DRAWING NO. D212-664-141	TITLE XTUBE ASSY (205/212/412 HI FWD)	REV. D	DART AEROSPACE LTD ENGINEERING ORDER		D.E.O. NO. D212-664-141-D-1	SHEET NO. SHEET 1 OF 2	SCALE NTS
DRAWN	CHECKED	MFG. APPR.	APPROVED	DE APPR.			
DATE 11.04.07	DATE 11.04.11	DATE 11.04.12	DATE 11/04/12	DATE 11.04.12

ADD AN INSPECTION WINDOW TO UNDERSIDE OF CROSSTUBE.

DRAWING NO. D212-664-141	TITLE CROSSTUBE ASS'Y (205 HI FWD)	REV. D	DART AEROSPACE LTD ENGINEERING ORDER		D.E.O. NO. D212-664-141-D-2	SHEET NO. SHEET 1 OF 1	SCALE NTS
DRAWN <i>UP</i>	CHECKED <i>AS</i>	MFG. APPR. <i>AS</i>	APPROVED <i>MD</i>		DE APPR. <i>MD</i>		
DATE 11.07.15	DATE 11.07.20	DATE 11.07.21	DATE 11/07/21		DATE 11.07.21

REPLACE MAGNOBOND WITH PROSEAL.

D212-664-141/-141B
ASSEMBLY DETAIL

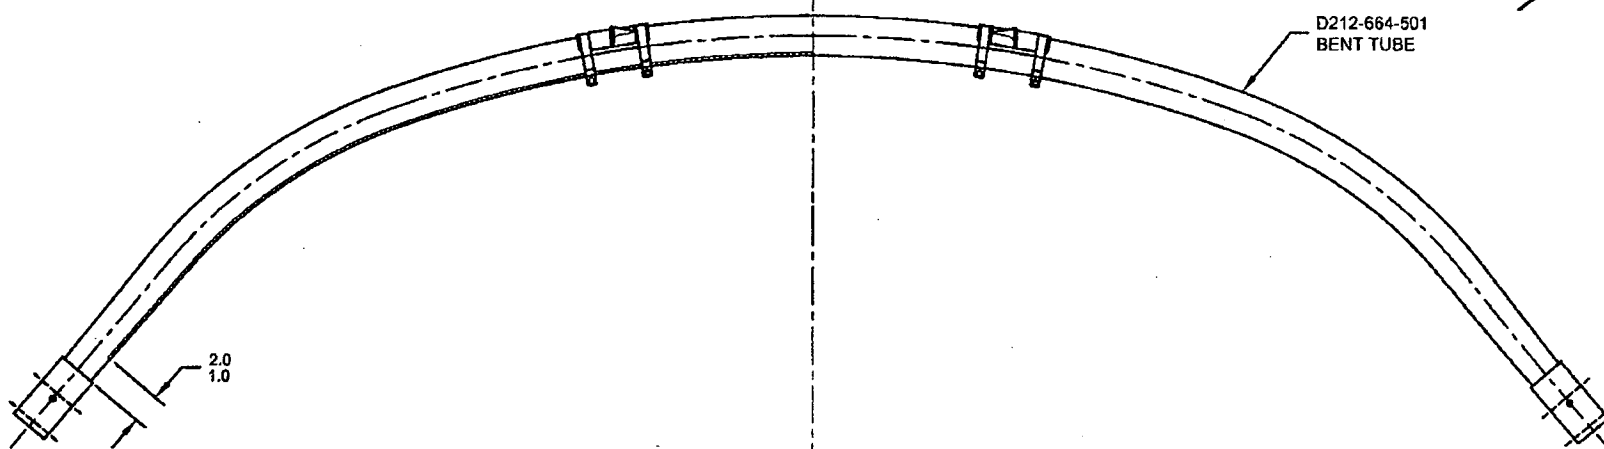
NOTES 2 OF SHEET 1 IS AMENDED AS FOLLOWS:

- 2) FINISH: CHEMICAL CONVERSION COAT PER DART QSI 005 4.1
PRIME INSIDE AND OUTSIDE PER DART QSI 005 4.2
MASK UNDERSIDE OF CROSSTUBE AS SHOWN (HATCHED AREA) AND
PAINT OUTSIDE PER DART QSI 005 4.2
REMOVE MASKING AND APPLY CLEAR COAT

MASK AREA PRIOR TO PAINTING,
REMOVE MASKING AFTER PAINT
AND APPLY CLEAR COAT
